Comment Letter O21

From: Richard James <rickjames@e-coustic.com>
Sent: Monday, March 03, 2014 3:12 PM
To: Hingtgen, Robert J
Cc: 'Donna Tisdale'; 'svolker'
Subject: Comments on Soitec Solar Development Draft Program Environmental Impact Report (DPEIR)
Attachments: 14-03-03 Comments on Soitec Solar Development.pdf

Response to Comment Letter O21

**E-Coustic Solutions on behalf of
 Backcountry Against Dumps/The Protect Our
 Communities Foundation/Donna Tisdale**

CNEL Calculation and Normalization Methods

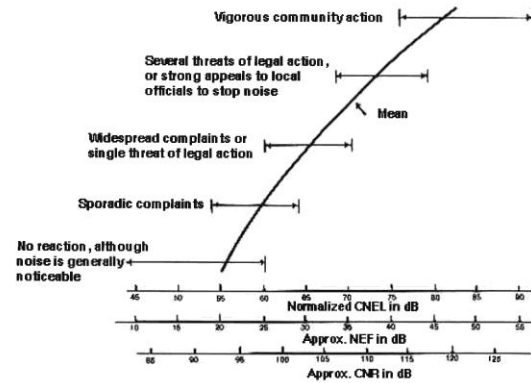
As stated above there is clear information in the EIR that some of the noise sources have tonal and/or impulsive characteristics. Proper application of the CNEL method requires that these characteristics be included in the calculations of the CNEL as a 5 dB penalty. See attachment to this document "CNEL Calculation and Normalization Methods" for these adjustments. The 5 dB adjustment for pure tones and impulses is found at the bottom of the table.

<p>compliance with County standards.</p> <p>O21-8 The noise analysis follows, and includes all the prescribed content from, the adopted County guidelines for noise assessment. We disagree that the analysis is deficient, in light of the fact that it complies with the requirements in the County guidelines for noise assessment.</p> <p>O21-9 The County guidelines for noise assessment do not incorporate the correction methodology prescribed by the referenced U.S. Environmental Protection Agency (EPA) document (NTID300.3, Community Noise, 1971). The calculation of community noise equivalent level (CNEL) values in the DPEIR is consistent with the County guidelines for noise assessment and the Noise Element of the County of San Diego General Plan that establish limitations on CNEL sound levels to be received by noise sensitive land uses. According to County of San Diego Guidelines for Determining Significance – Noise (2009), the method for calculating CNEL is as follows:</p> <p>1.1.4 Community Noise Equivalent Level (CNEL)</p> <p>This term applies weights to noise during evening and nighttime hours to compensate for the increased sensitivity of people to noise at those times. CNEL is the equivalent sound level for a 24-hour period with a +5 dB weighting applied to all sound occurring between 7:00</p>
